SERVICE INFORMATION NO. SI 42-011

Garmin G1000 – Covers on GIA 63 units
ATA-Code: 34-00

**** MANDATORY ****
SERVICE BULLETIN

SUBJECT: GIA 63 Outside Covers

Figure 1, GIA 63, Cover Layout

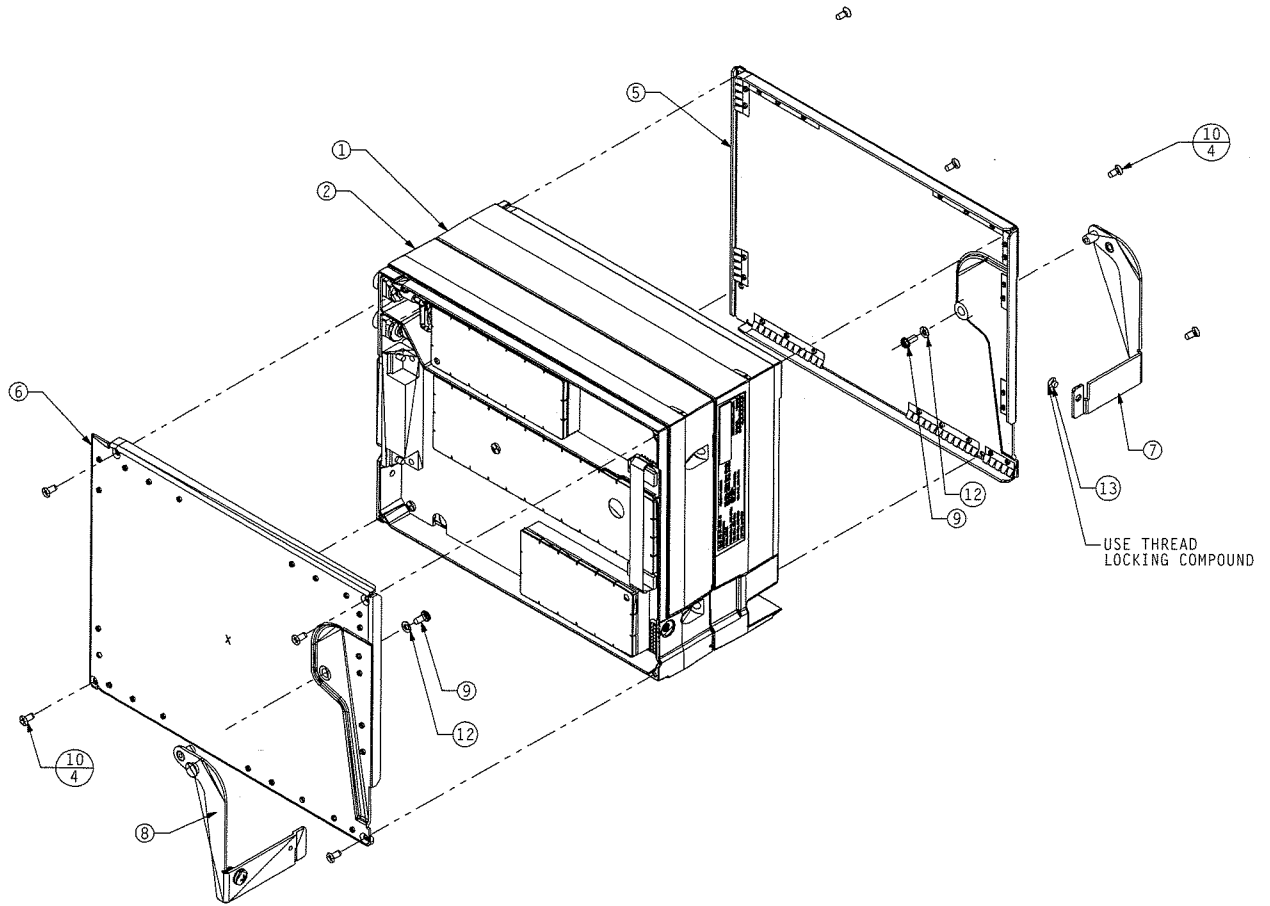
On certain GIA 63 units, finger stock mounted inside the left and right covers (Main and Nav) could become detached.

This modification consists of removing and replacing the left and right covers on the GIA 63. GIA 63, P/N 011-00781-00 units with serial numbers 46905865 and below and GIA 63, P/N 011-00781-01 units with serial numbers 48101165 and below are affected.

Covers that **do not** have small circular indentations (indicating extruded riveting) along the outer edge on the Main and Nav covers, are affected. The appearance of extruded rivets on the covers indicate that this Service Bulletin has been complied with.

1. Remove screw (13) from handle (7, 8).
2. Remove four screws (10) from cover (6).
3. Remove screw (9) and washer (12) from handle (8).
4. Remove handle (8) from cover (6).
5. Ensure all finger stock is removed with the old cover.

1. Attach handle (8) to new cover (6) with screw (9) and washer (12). (Add thread lock compound on items 9 and 13)
2. Attach new cover (6) to chassis (2) with four screws (10).

1. Remove four screws (10) from cover (5).
2. Remove screw (9) and washer (12) from handle (7).
3. Remove handle (7) from cover (5).
4. Ensure all finger stock is removed with old cover.

1. Attach handle (7) to new cover (5) with screw (9) and washer (12). (Add thread lock compound on items 9 and 13)
2. Attach new cover (5) to chassis (1) with four screws (10).
3. Attach handles (7) and (8) with screw (13).
